MODEL BENTLEY MARK VI

MODIFICATIONENGINE OIL FILLER CAP WASHER.

REPLACEMENT OF TAPPETS.

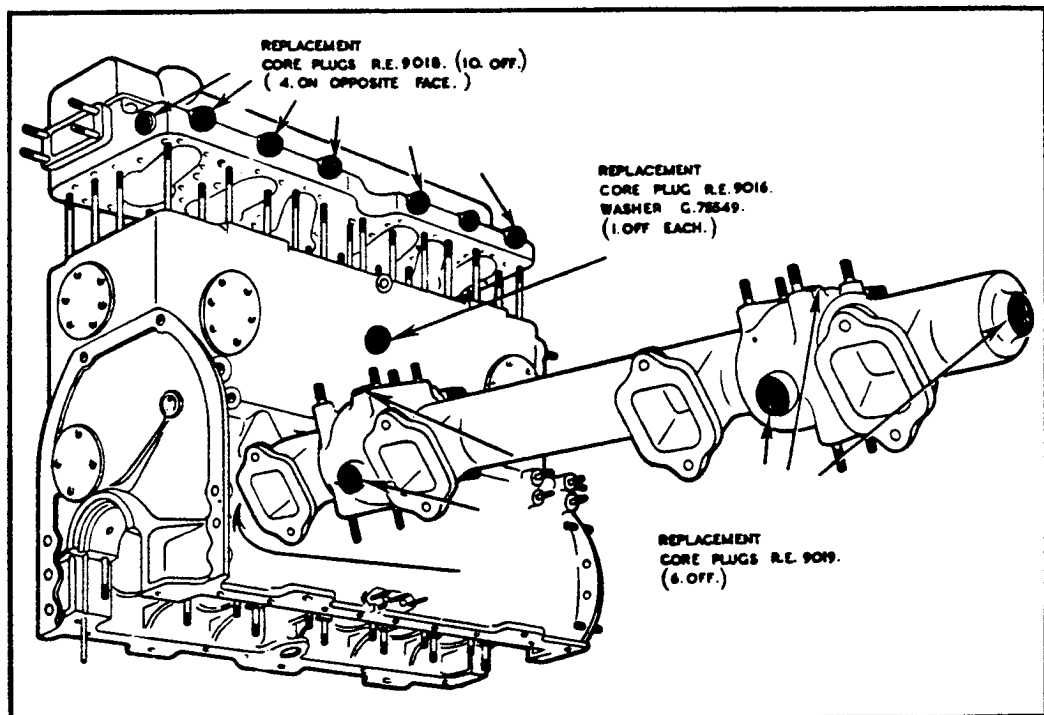
Bentley Service Bulletin BB-19 deals with the replacement of engine core plugs on a Category 2 basis, conditional upon partial or complete overhaul.

The following illustration gives fuller details of the location of the core plugs to be replaced, together with replacement part numbers.

It should also be noted that if a coolant leak develops from any of the core plugs when the engine is fitted with the pre-modified type, this may indicate that a state of corrosion exists in other core plugs caused initially by the engine remaining drained of coolant for lengthy periods of storage or shipment. If a leak is apparent therefore, the instructions given in Bulletin BB-19, limiting this modification to overhaul cases only, must be disregarded, and all core plugs replaced with the modified type.

FIG.1. SECTION - CYLINDER-SHOWING COUNTERBORE.

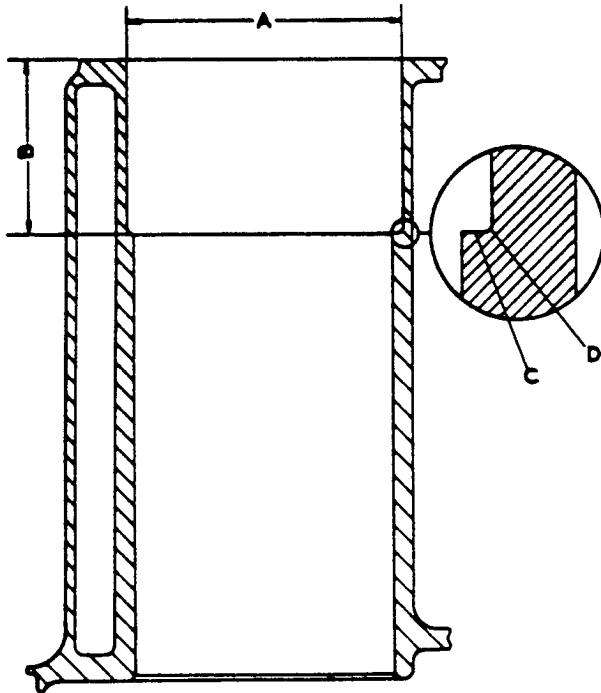
- (iv) Repeat for the remaining bores.
- (v) Before pressing in the liners, ensure that the radius, 'D' Fig.1, is smaller than the chamfer ('F' Fig.2) on the lower end of the liners, so that there will be no interference at the butt joints when the liners are pressed fully home.

NOTE: If, when measuring the diameter of a counterbore ('A' Fig.1), it exceeds 3.6265" (92.11 m/m), it will be necessary to fit an R-4610 oversize short liner. This liner is marked with white paint and has an external diameter of 3.631" to 3.632" (92.23 to 92.25 m/m), and one should be selected that will not allow an interference exceeding .004" (.1 m/m), or less than .0025" (.06 m/m).

FIG.2. SECTION - CYLINDER - SHORT LINER IN POSITION.

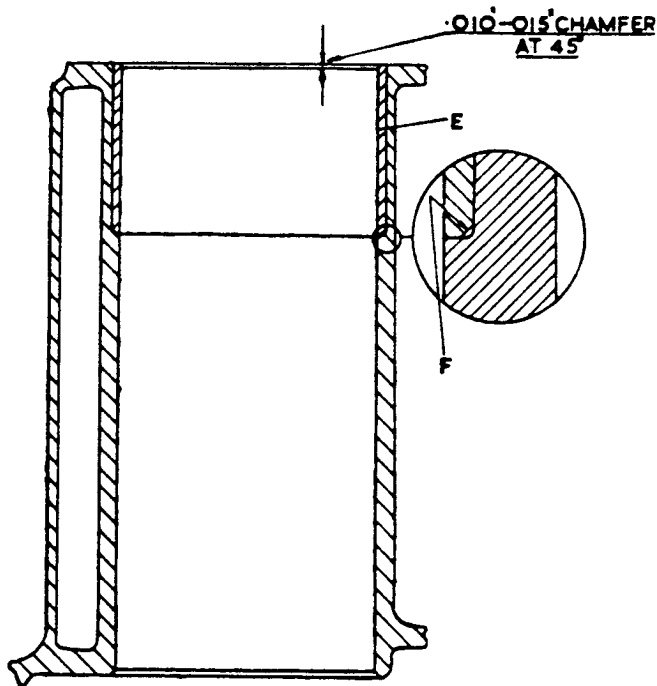
- (ix) With a half-round scraper, cut a .010" to .015" (.25 to .38 m/m) chamfer at about 45° at the upper end of each liner, as shown in Fig.2.
 - (x) If removed, replace the cylinder head holding down studs.
 - (xi) Next, hone the bores to the required standard oversize diameter. (See table 'a' of Para.1). Due to the difference in textures of the liners and the cast iron cylinders, special care should be taken when honing to guard against the possibility of scoring.
3. TO BORE A CYLINDER BLOCK TO A STANDARD OVERSIZE DIAMETER ON WHICH SHORT LINERS WERE ORIGINALLY INCORPORATED (CHASSIS NO. B-144-DA AND ONWARDS):

If short liners ('E' Fig.2) have not been incorporated (on chassis prior to B-144-DA), it will be necessary to counterbore the unaffected (un-scored) cylinders at their upper end and fit a short Bricrome liner, RE-6017; irrespective to fitting twin liners to one or more of the bores.

PLAIN (TOP) FACE.

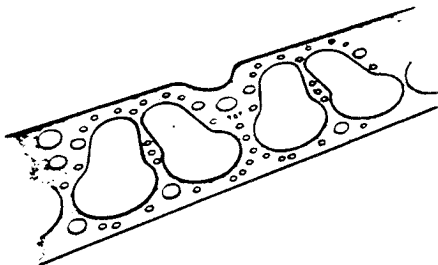
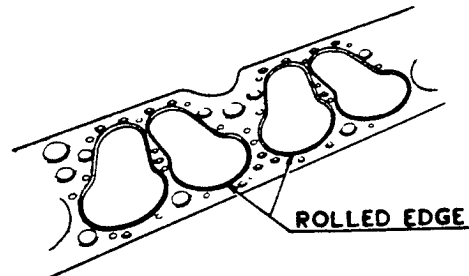
Retailers are advised that the correct procedure when fitting replacement C & A cylinder head gaskets in service is to ensure that these are fitted with the plain face uppermost and the rolled, or lapped, face to the cylinder block.

As an aid to recognition the characteristic differences between the top and bottom faces of the gasket are illustrated in the above two sketches. A further means of identification is provided by the word "TOP" which will be found stamped between Nos. 3 & 4 cylinder openings on the plain face as shown.

FIG. 3. FRONT ELEVATION - FULL FLOW OIL FILTER.

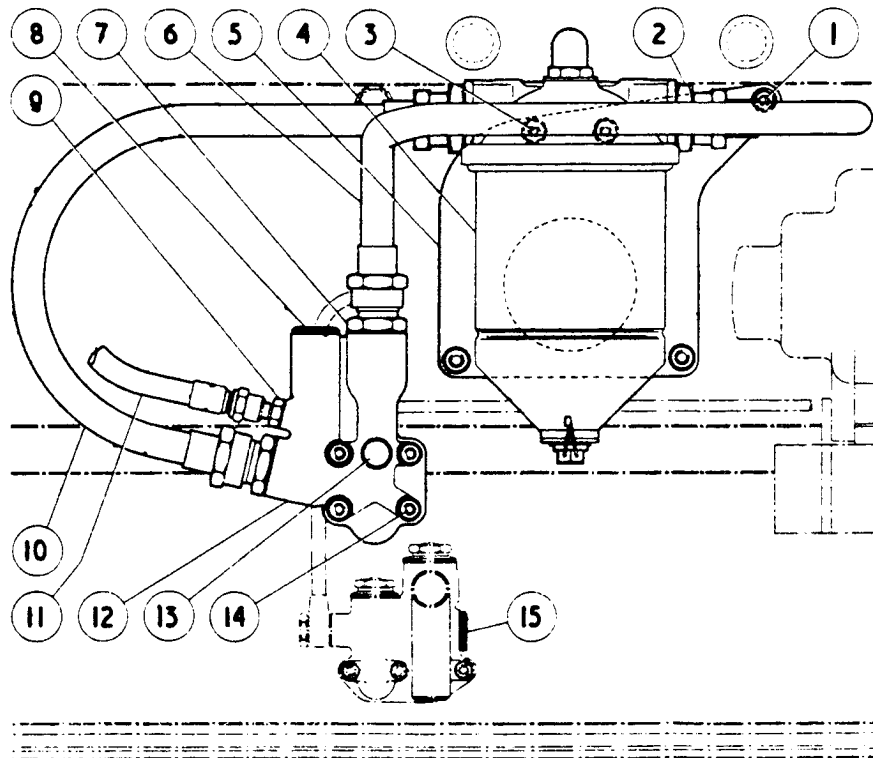
SCHEME 'A' conforms to the layout shown in Fig.3, and is relatively simple in installation, being confined to external alteration only. It can be applied to engines, the crankcase of which have the adaptor facing referred to above. Generally speaking, this modification to the crankcase was first introduced at the commencement of 'H' series to provide a means of employing full flow filtration on unit test, and in anticipation of the scheme becoming standardised later. Crankcases of this type may be recognised by reference to Figs. 1 & 2, which show special adaptors used in conjunction with the original By-Pass Filters.

- File back the face of the lug until the filter mounting plate(5) when offered up to the crankcase lies FLAT against this lug and the two lower studded lugs.

FIG. 4. SECTION SHOWING MODIFICATION TO CRANKCASE FOR OIL FEED STANDPIPE.

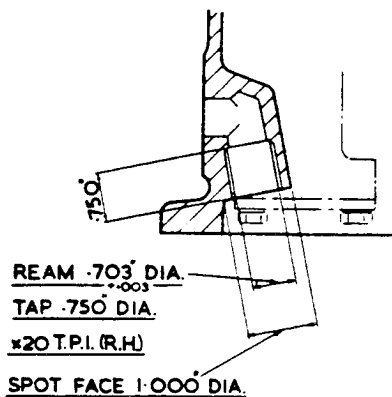
- (i) Remove the oil relief valve overflow pipe, (11/16"dia) from the interior of the crankcase, by twisting to shear the small securing taper pin. With a suitable punch tap out the remaining portion of the pin from the crankcase. For position of pin, refer to point 'A' Fig.7. Remove the sheared portions.
- (ii) Plug the pin hole by first tapping it with the 3-BA taper tap sufficiently to make the screw, K-1813 an interference fit. To prevent the screw protruding into the bore of the overflow pipe hole, shorten it to $\frac{3}{8}$ " (9.5m/m) measured from underside of head. Fit screw and remove head flush with crankcase and finally peen over to secure.
- (iii) With the R-4743 (.703"dia) piloted parallel reamer, ream out the hole in the crankcase from which the overflow pipe has been removed and tap .750"dia 20 T.P.I.-R.H. using both taper and plug taps(See Fig.4).

FIG. 8. SCRAP VIEW SHOWING CRANKCASE LUG ('A').

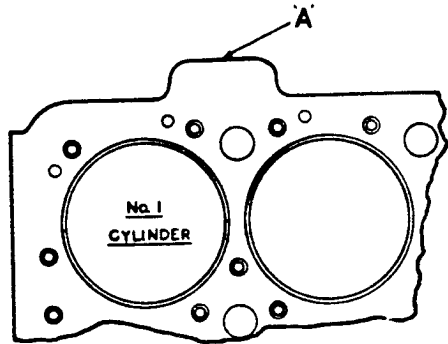
- (vi) File back the face of the crankcase front lug, 'A' Fig. 8 and fit the stud (1) KB-751/Z as described in sub-para. (iv) of Para. 3 for Scheme 'A'.

NOTE: In the unlikely event of the lug having been machined back on an engine prior to 'H' series chassis, then it will be necessary to fit the circular distance piece (23 Fig. 10) interposing it between the filter mounting plate and the lug when fitting the mounting plate and filter assembly to the crankcase as described in Sub-para. xv.

FIG. 9. FRONT ELEVATION - FULL FLOW OIL FILTER.

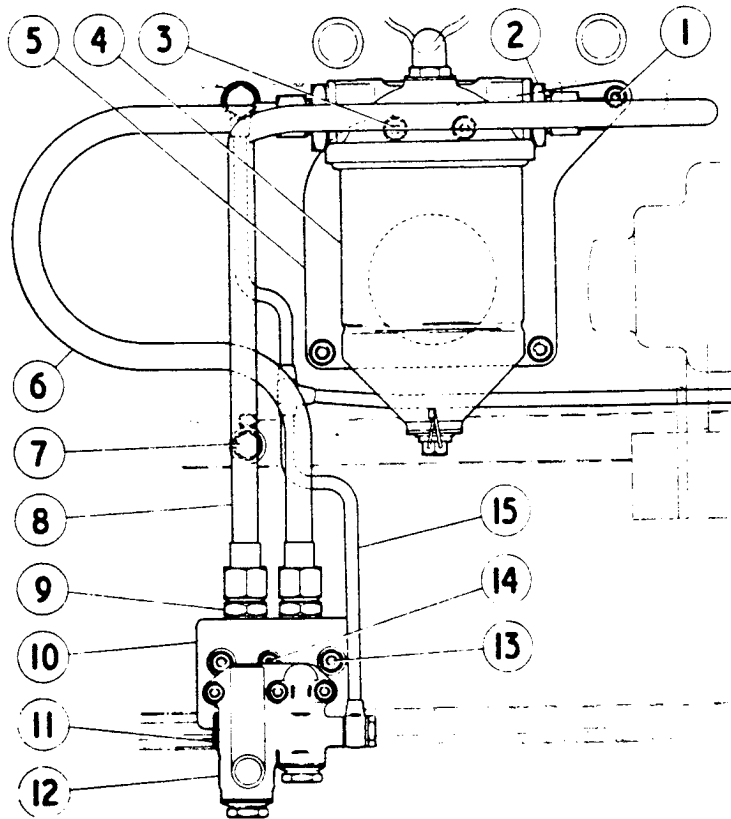
- (xi) Remove the union from the oil relief valve unit and fit the core plug (11) and joint washer. Place the unit and the Vellumoid joint (EB-3953) on to the transfer block. While tightening up the three nuts to secure, check that the end of the centre stud (14) or nuts securing the transfer block to the crankcase do not foul the casing of the oil relief valve unit. The unit is inverted for fitting under this arrangement as shown in Fig.9.

FIG. 11. CRANKCASE LOWER HALF.

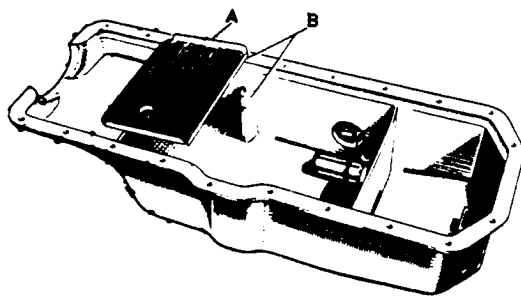
- (xiii) When offering up the lower half of the crankcase, it will be found that the union nut securing the oil feed pipe to the standpipe (24) fouls the oil baffle ('A' Fig.11) and the locating lug at points 'B'. Remove the baffle and file the lug until it just clears the nut and then file the edge of the baffle to suit. It may also be necessary to file the inside of the lower half of the crankcase to clear the nut. Refit the baffle.

FIG.1 LOCATION OF CORE PLUGS

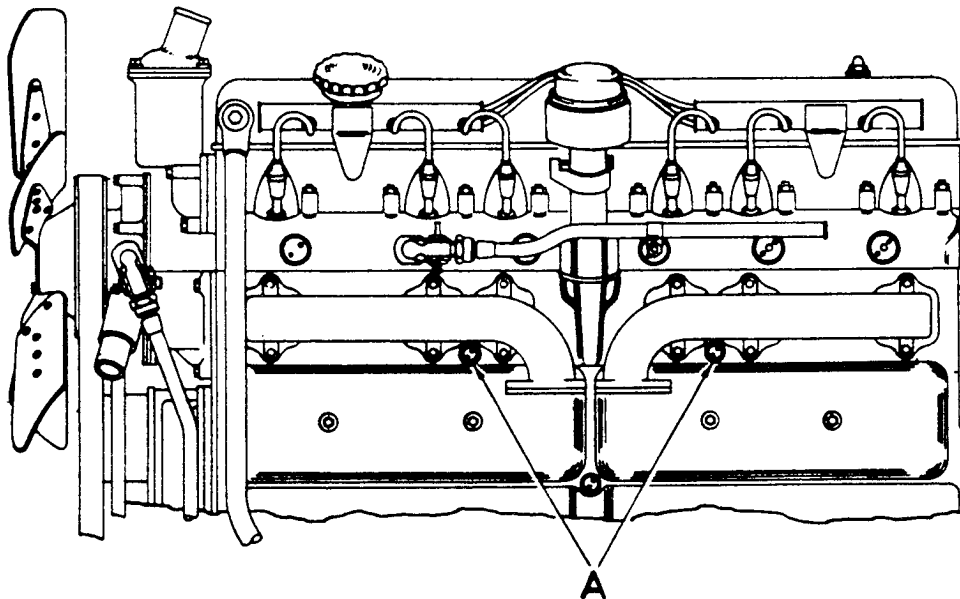
On certain $\frac{5}{8}$ " bore engines two aluminium alloy core plugs were fitted on the left hand side of the crankcase above the tappet covers as shown at A Fig.1.

The aluminium plugs have proved subject to corrosion in service and are to be replaced with cadmium plated steel core plugs and aluminium washers as a retrospective modification. Retailers are asked to carry out replacement on all affected cars in their area when they are next being serviced.

- (i) Drain the cylinder block.
- (ii) Remove the aluminium core plugs, clean the threads with the tap provided and fit the steel plugs and aluminium washers.
- (iii) Refill the cooling system.

FIG.1.
RADIUS ON FLYWHEEL TEETH.

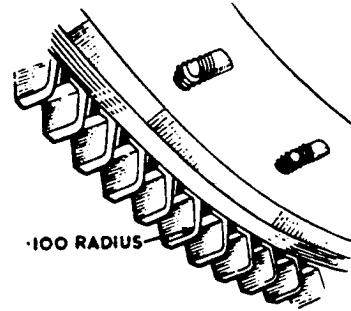
The flywheel ring gear teeth are also to be radiused .100" (2.54 mm) to remove the sharp corner on the engaging face.

Fig.1 Outer Lip Proud of Inner Sealing Face.

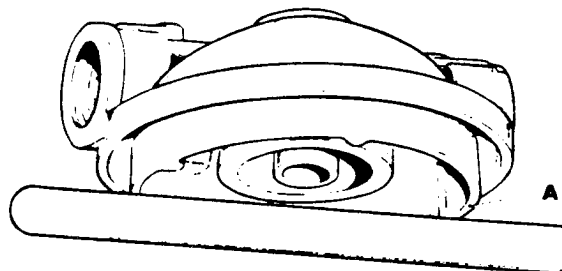
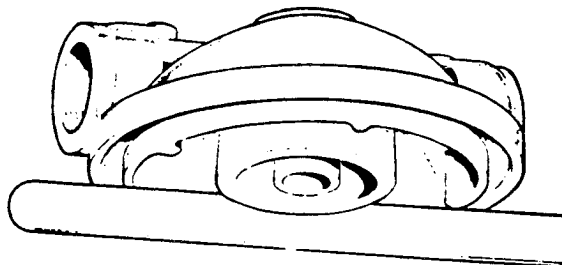
It has been established that on a small number of 'Vokes' Full-Flow Oil Filters it is possible for the oil to pass across the filter head without passing through the filter element. This condition is only possible when the outer lip of the filter head (see A Fig.1) stands proud of the inner sealing face.

Therefore when the bowl of the filter is removed to change the filter element and seals, on the 5,000 miles service schedule, Retailers should check the filter head with the aid of a straight edge as illustrated in Figures 1 and 2.

If the outer lip is found to stand proud of the inner sealing face (see Fig.1), a modified 'Top Cap' (see Fig.3) should be fitted and the original discarded.

If the inner sealing face stands proud of the outer lip (see Fig.2) the original 'Top Cap' (as shown in Fig.4) can be retained. For future replacements only the modified 'Top Cap' will be supplied.
